T.I. No.: 2021-12 Updated: -	Topic: Product optimisation - Holder brewing unit
---	--

New holder brewing unit with improved design

**HOLDER BREWING UNIT
NEW
067 969**

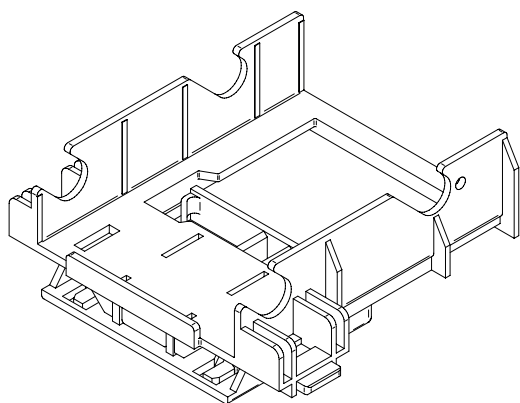
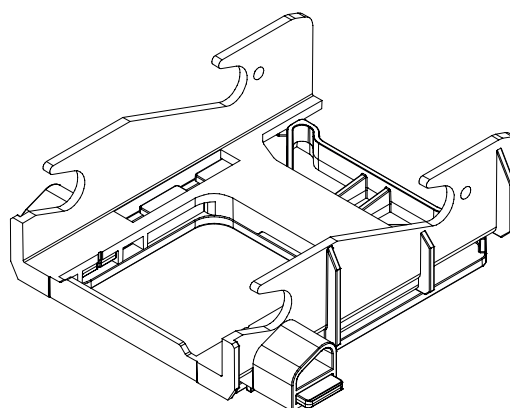
The previous holder brewing unit **33.2823.7000** has been improved and is replaced by the new holder brewing unit **067 969**. Improved design reduces coffee grind contamination inside the machine.
